ITEM #2 - PRELIMINARY PLAT GLACIER VIEW SUBDIVISION NO 28

KPB File No.	2024-041
Plat Committee Meeting:	May 28, 2024
Applicant / Owner:	William Miller of Homer Alaska
Surveyor:	Brett Wilmot / Peninsula Land Surveys
General Location:	Klondike Ave in City of Homer

Staff Report 23-050

SUBJECT: Glacier View Subdivision

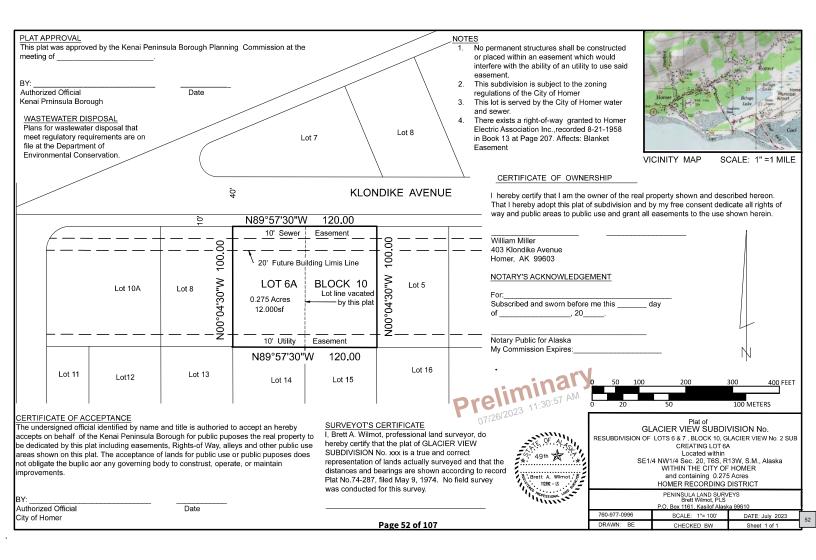
Staff Response: The plat does not meet this requirement. The plat notes a 10-foot sewer easement. Recommend noting a 15-foot-wide utility easement on the plat or provide an explanation on how this requirement cannot be met and request an exception.

Staff Response: The plat meets these requirements. Does the surveyor intend on adding a number to the subdivision title?

Staff Response: The plat does not meet these requirements. Recommend the surveyor provide the approximate location of known existing municipal wastewater and water mains, and other utilities within the subdivision and immediately abutting thereto or a statement from the city indicating which services are currently in place and available to each lot in the subdivision to the preliminary plat.

- 1. Recommend noting a 15-foot-wide utility easement on the plat or provide an explanation on how this requirement cannot be met and request an exception.
- 2. Does the surveyor intend on adding a number to the subdivision title?
- 3. Recommend the surveyor provide the approximate location of known existing municipal wastewater and water mains, and other utilities within the subdivision and immediately abutting thereto or a statement from the city indicating which services are currently in place and available to each lot in the subdivision to the preliminary plat.
